APPROVED 9-6-1966	DEPARTMENT OF ENGINEERING		
REGISTERED CIVIL ENGINEER No. 13655	CITY OF SAN BERNARDINO		
DRAWN BY BILL	IMPROVEMENT PLAN		
CHECKED BY	ARROWHEAD AVE FROM ℄ OF 3RD ST TO ℄ OF BASE LINE ST AND FROM ℄ OF HIGHLAND AVE TO ℄ OF 27TH ST		
RECOMMENDED	STREET REPAIR PAVING		
DRAWING No. 3498	SHEET 1 OF 2 SHEETS

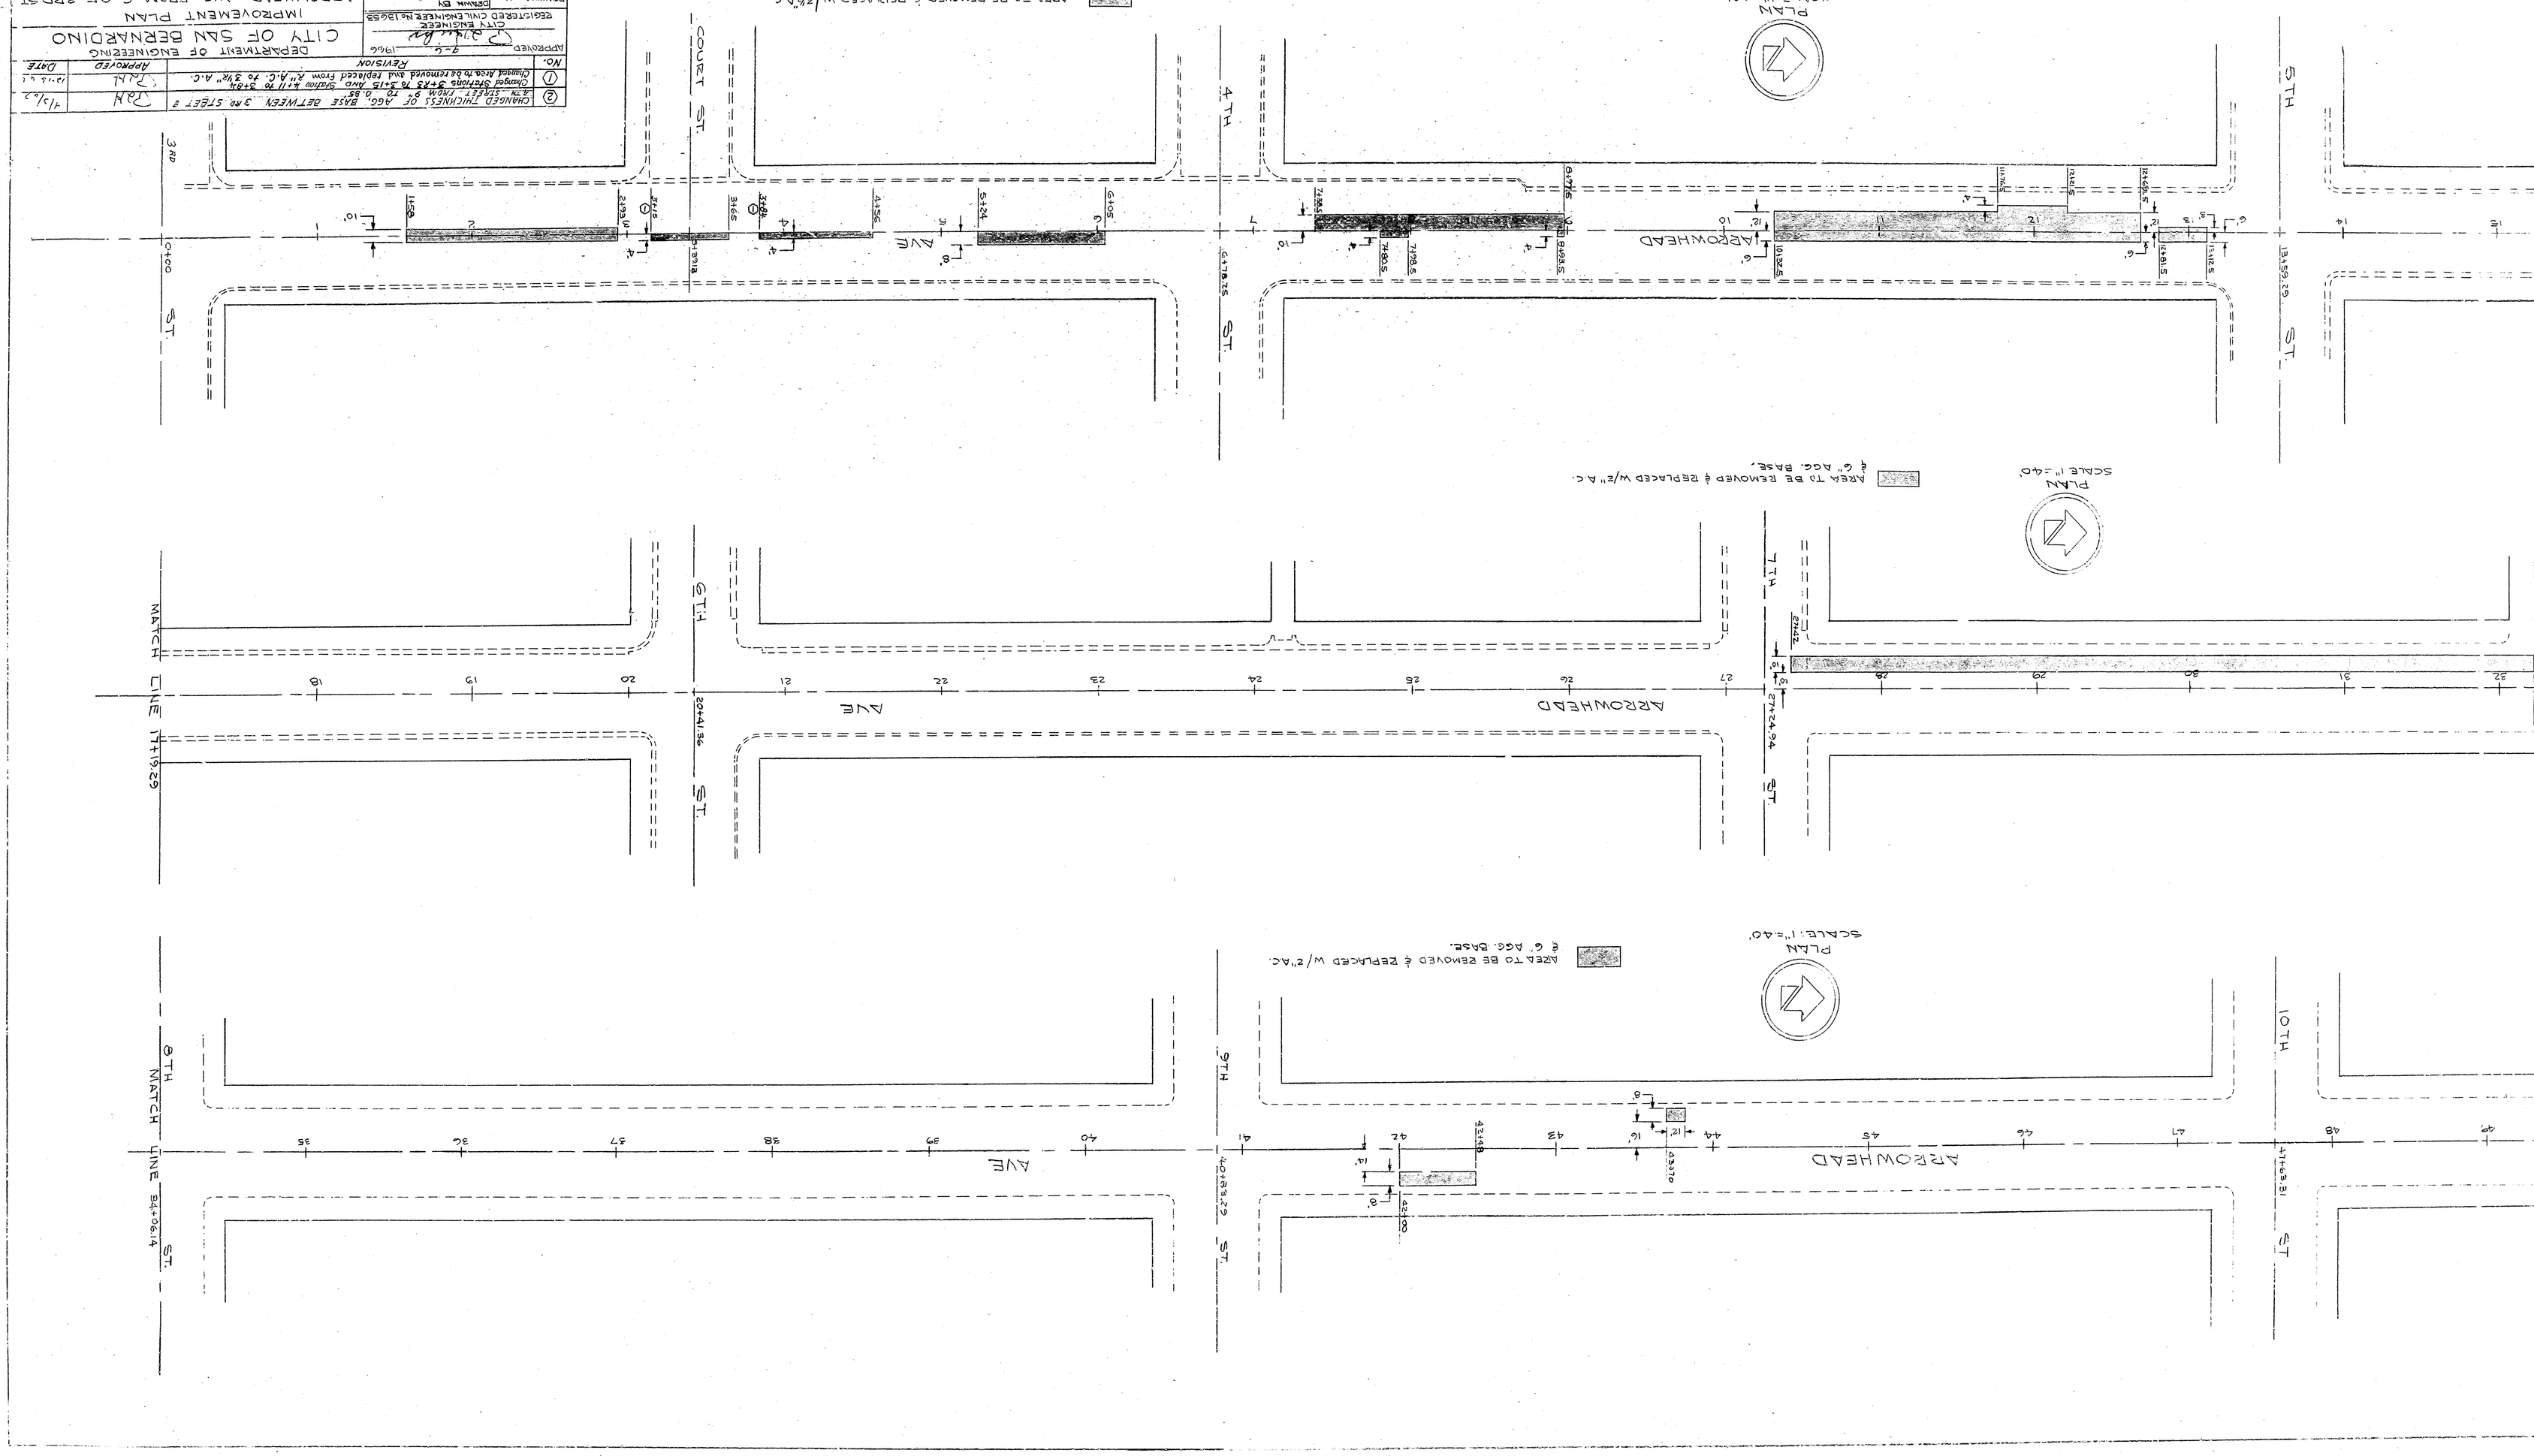
No.	REVISION	APPROVED	DATE
2	CHANGED THICKNESS OF AGG. BASE BETWEEN 3RD STREET & 4TH STREET FROM 9" TO 0.85	JAH	1/31/62
1	Changed Stations 3+83 To 3+15 And Station 3+84 To 3+68 Changed Area to be removed and replaced from 2" A.C. To 3½" A.C.	JAH	12-18-61
